BART Seismic Retrofit Project

Berkeley Hills Tunnel to the Montgomery Street Station

ENVIRONMENTAL ASSESSMENT

Response to Comments

Figure 1. Barge Anchoring Layout and Profile for Vibro-Replacement at the San Francisco End

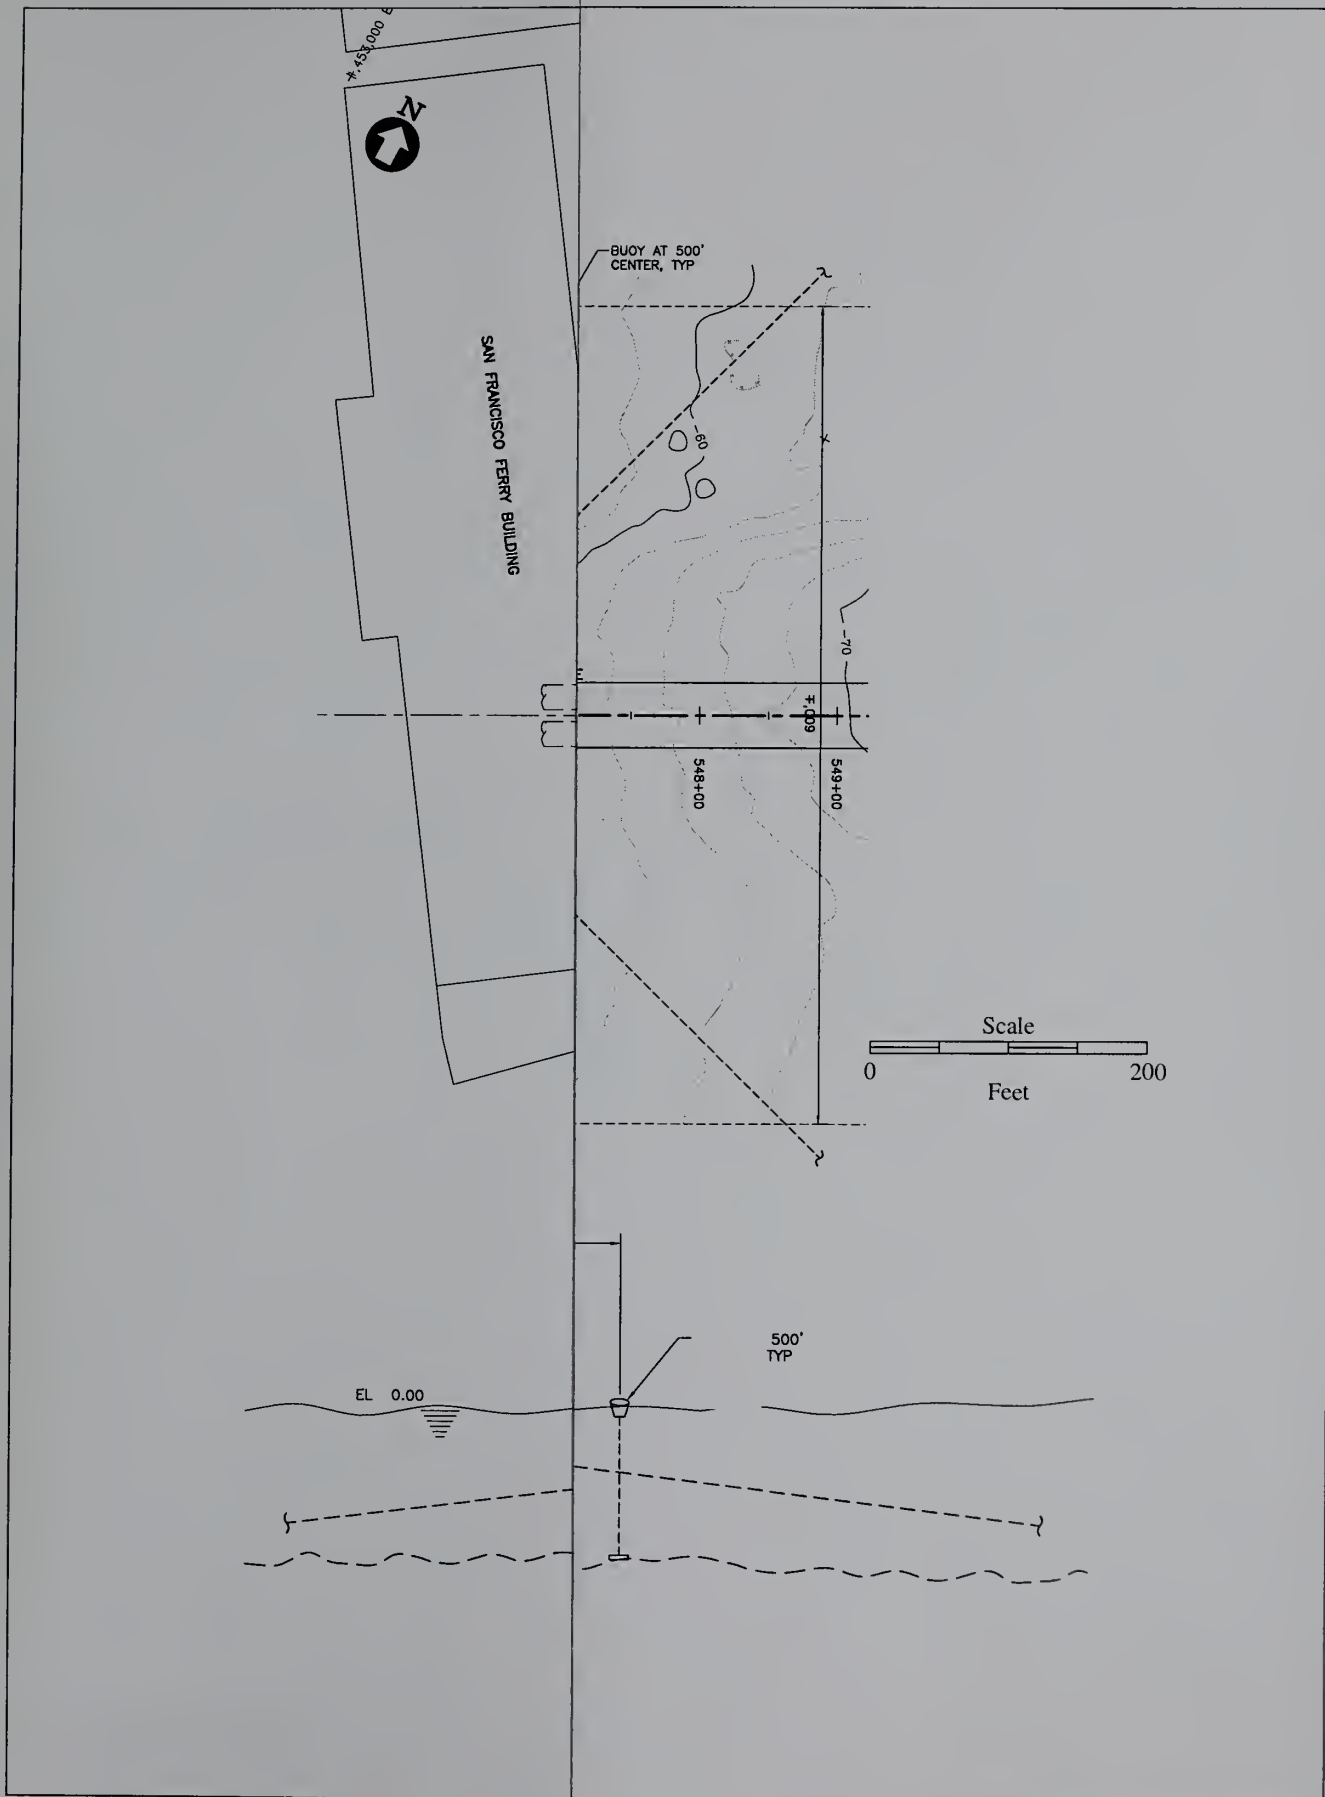
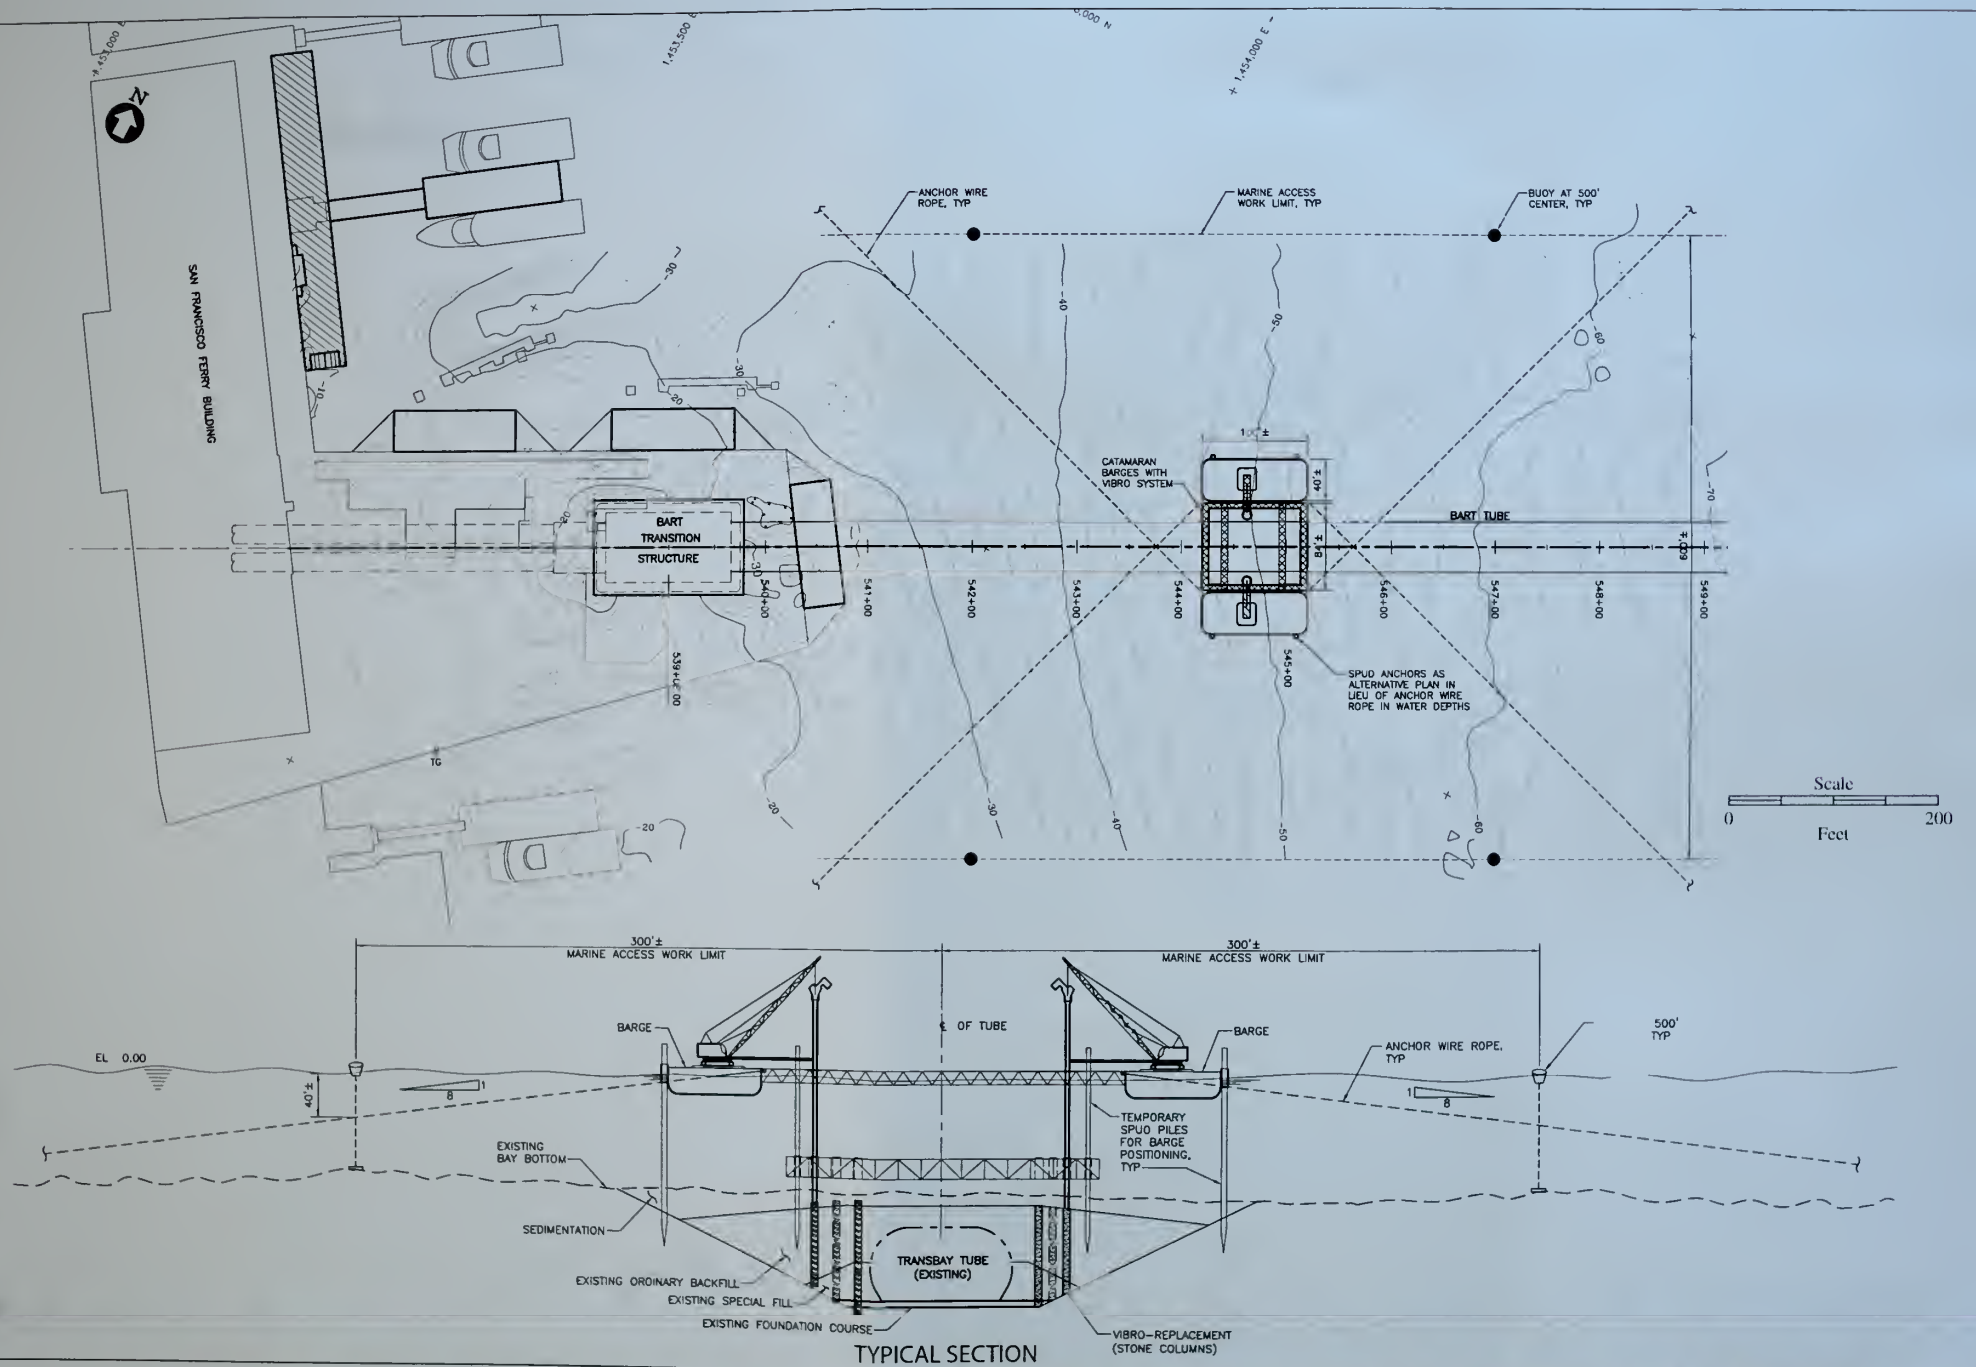
- F-16 • Figure 2-3 is a schematic that depicts a plan view on top and a section view on the bottom. The section view includes “Wire Lines to Anchor” at a rather steep slope. Is this depiction correct? Typically barges place anchors such that the angle of the lines is much flatter, so that the barge can be positioned using the anchor lines, resulting in the anchor lines extending a considerable distance away from the barge. This is germane, because the anchor lines may interfere with ferries in the vicinity of the Ferry Terminal. The plan view at the top of the exhibit does not depict the anchor lines. It would appropriate to show the anchor lines in plan view to provide the necessary detail to determine whether there is likely to be an impact.

Figure 1, below, depicts the full of extent of barge work areas in plan view within the vicinity of the San Francisco Ferry Plaza Platform (Platform), and clarifies EA Figure 2-3 depicting proposed vibro-replacement activities at the San Francisco end of the Tube. As indicated in Figure 1, spud anchors would be used in water depths up to 50 feet in lieu of anchor wire rope to avoid interfering with ferry movement. Therefore, project construction activities associated with vibro-replacement will not interfere with ferry operations in the vicinity of the San Francisco Ferry Terminal.

2 F-16. Additional details regarding vibro-replacement activities at the San Francisco end have
3 been integrated into Figure 1, including the full extent of anchor wire rope lines and
4 barge work area limits. Figure 1 demonstrates that the length and depth of the anchor
5 lines would not interfere with ferry operations in the project vicinity. Furthermore,
6 spud anchors would be used in lieu of anchor wire rope in water depths up to 50 feet to
7 avoid interfering with ferry movement.
